**Transmittal  
Report of Results  
Basis for Site Remedy Revised Addendum  
39155 and 39183 State Street  
Fremont, California**

**Subject:** Basis for Site Remedy Revised Addendum  
39155 and 39183 State Street  
Fremont, California

**Project No.: 220.003.03.003**

## TRENCH DAM & TRENCH PLUG PLAN STATE STREET CENTER

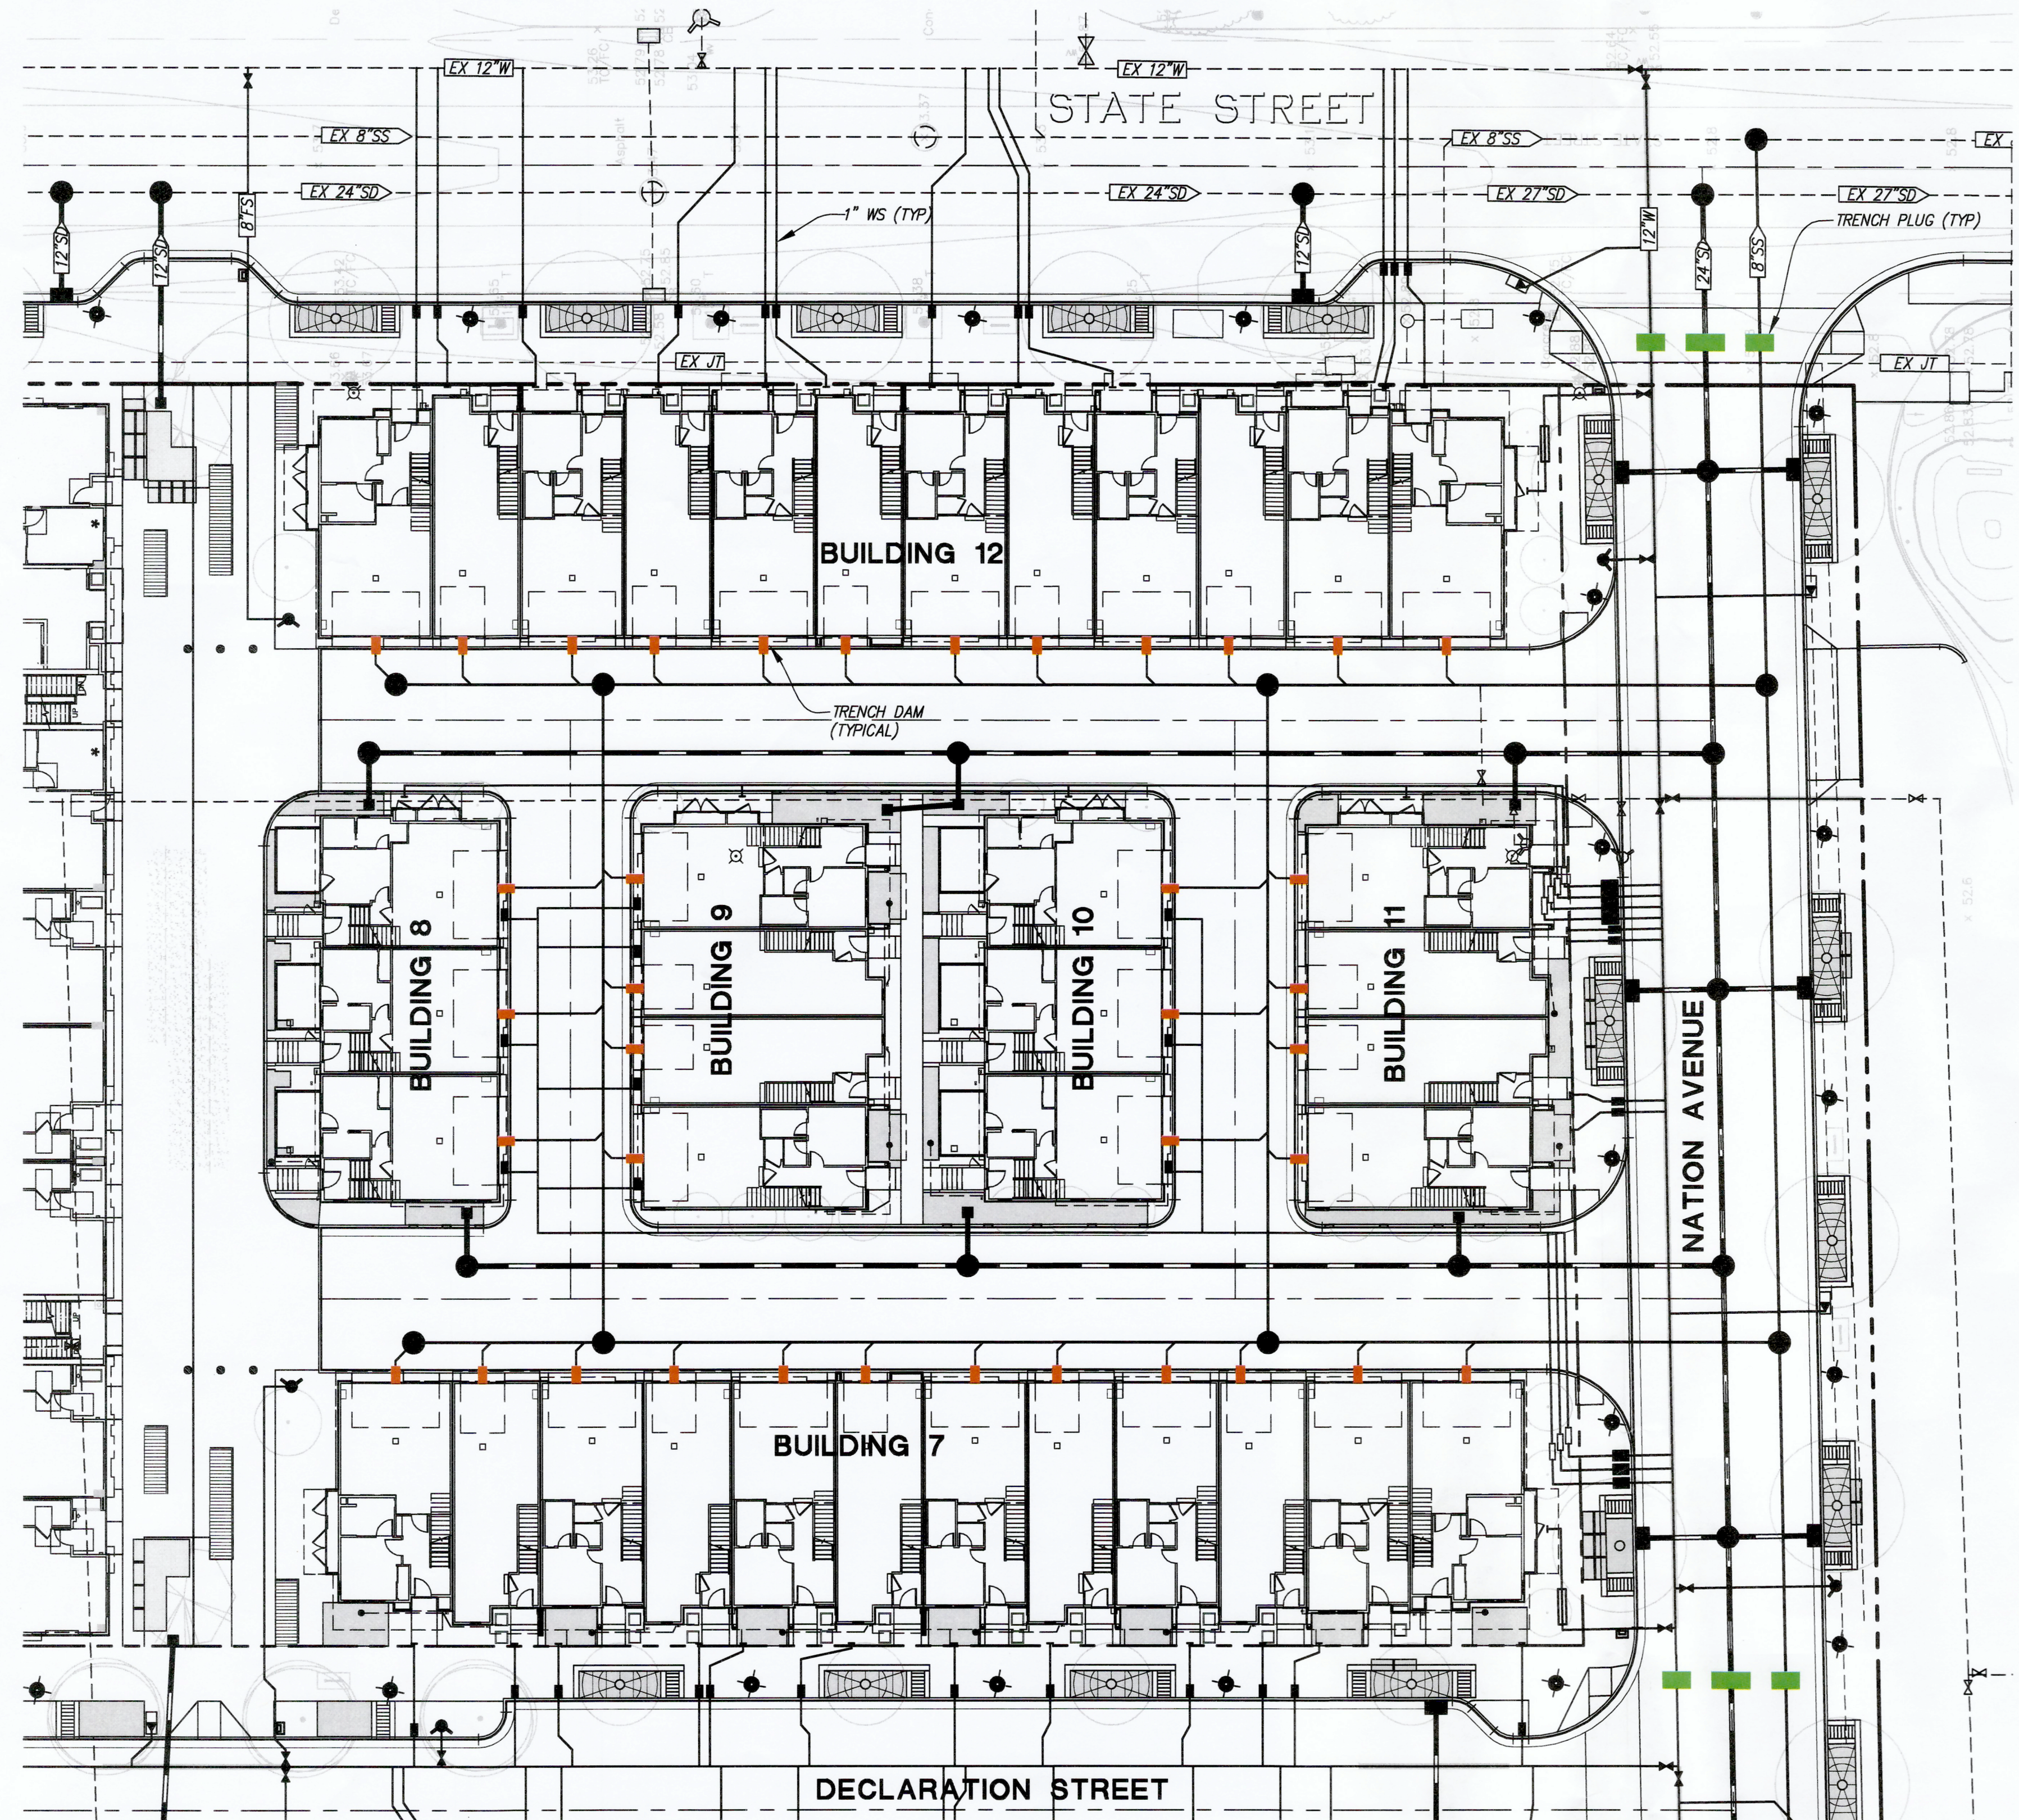
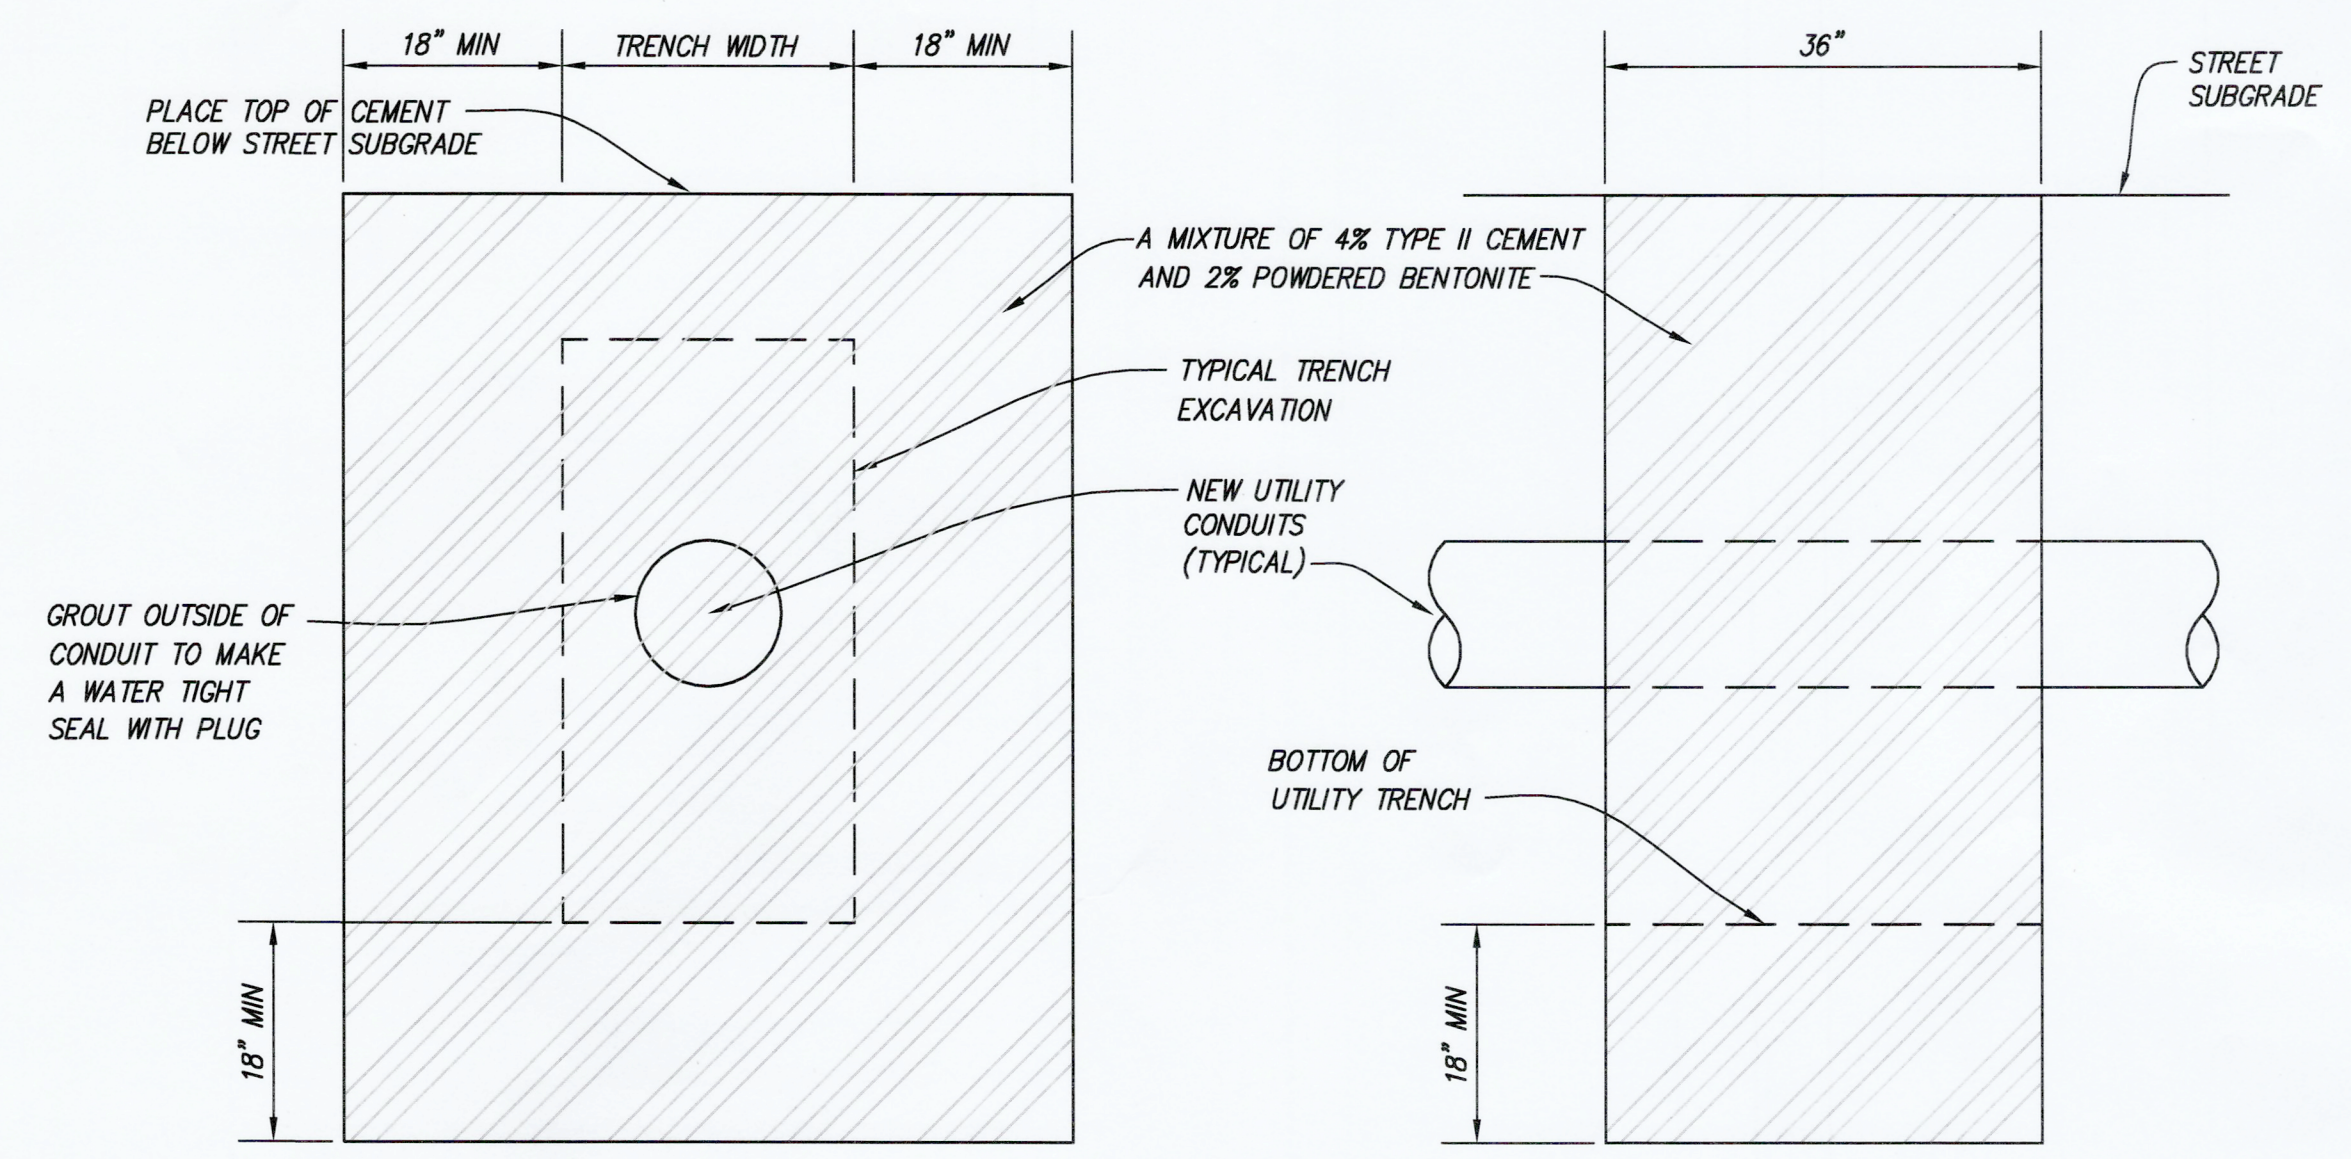
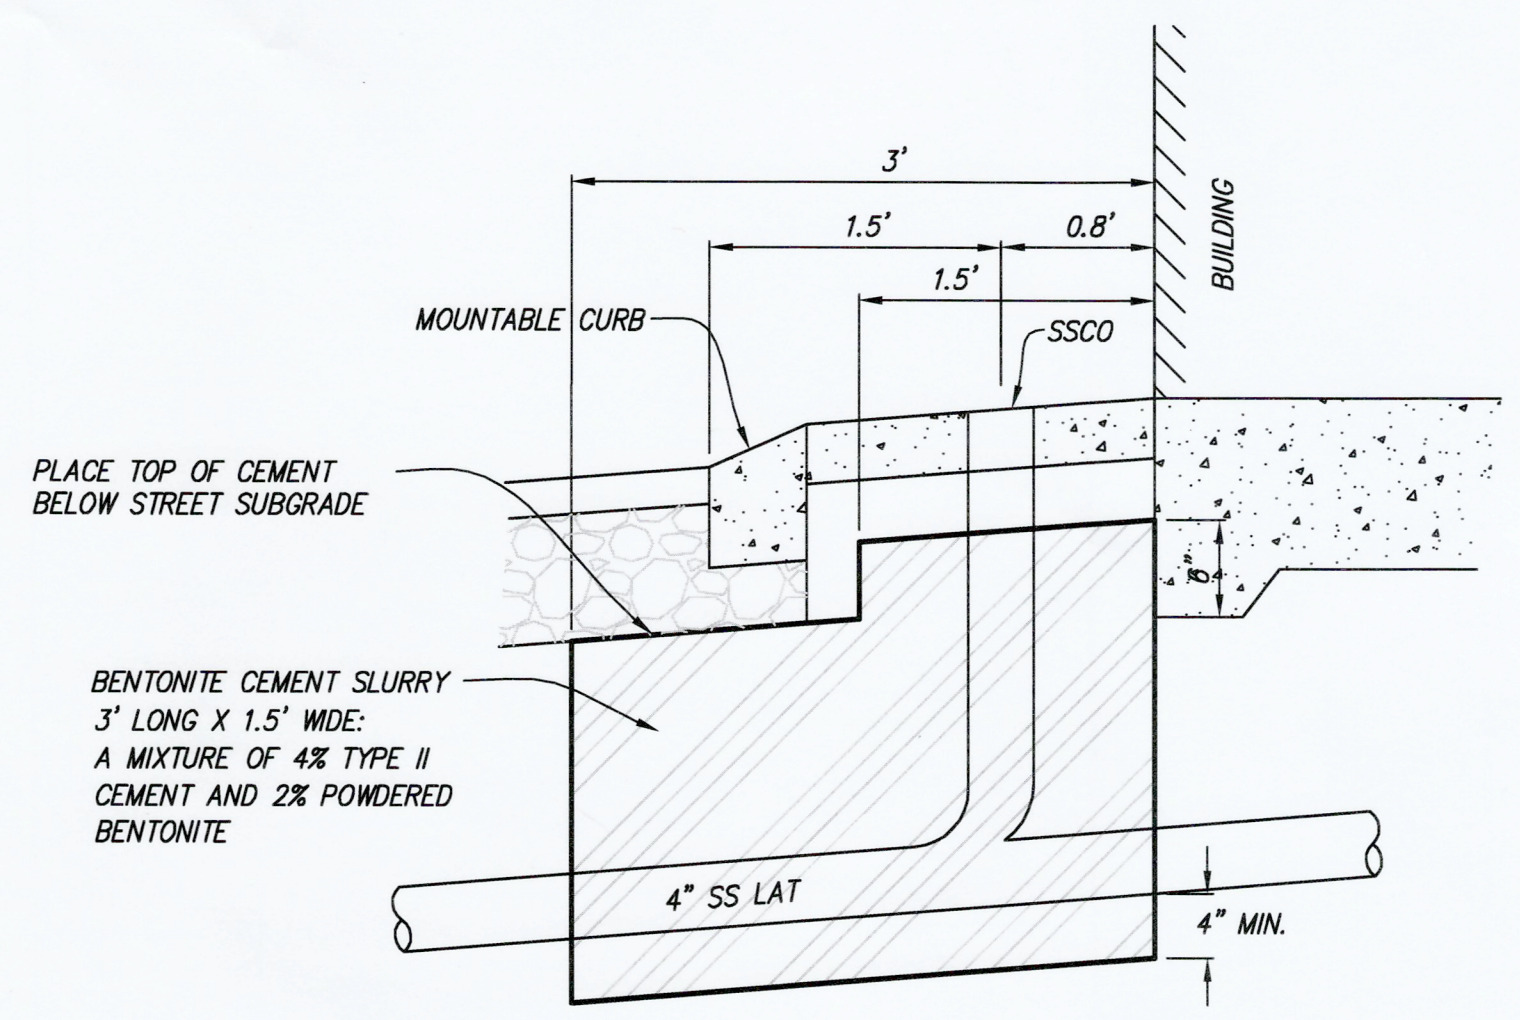
Trench dams will be used as a gas migration barrier (to minimize PCE soil vapor intrusion into the buildings north of Declaration Street) and shall be installed in all utility trenches that extend beneath the foundation from areas outside the perimeter of the building. The trench dams shall be installed in the utility trenches immediately adjacent to the exterior of the building foundation to prevent soil gas migration beneath that foundation. It has been determined that the sanitary sewer laterals for Buildings 7 through 12 are the only utility that extend beneath those building foundations from outside the perimeter of the building. The attached Plate 1 provides the proposed locations where the sanitary sewer utility lines will require trench dams. The trench dams will be installed in the sanitary sewer utility trench immediately adjacent to the exterior of the building foundation and be approximately 3 feet in length and 1.5 feet in width. The trench dam detail was developed in accordance with the City of Los Angeles, Department Building and Safety's Methane Hazard Mitigation Standard Plan details. Appendix B includes the Trench Dam & Trench Plug Plan construction drawing that shows the proposed trench dam locations and a trench dam detail. As shown on the trench dam detail, there will be a sanitary sewer riser/cleanout within each trench dam.

The trench dams and trench plugs will be constructed using bentonite cement slurry. The bentonite cement slurry will consist of a mixture of 4% Type II cement and 2% powdered bentonite with clean sand and water. A temporary plywood frame will be constructed in the trench to serve as a form into which the slurry is placed. The slurry will be poured directly into the trench and allowed to harden in place for at least 24 hours. After the slurry has hardened, the temporary form can then be removed or remain in place. The trench dams and trench plugs will be shown on construction plans to be approved by the City of Fremont. Inspection of the trench dam and trench plug construction activities will be performed to verify conformance with the attached Trench Dam & Trench Plug Plan construction drawing included in Appendix B. The trench dams and plugs will also be surveyed. The trench dam and trench plug installation activities will be documented in the VMS construction completion report that will be submitted to ACEH for review and approval following installation of the VMS.
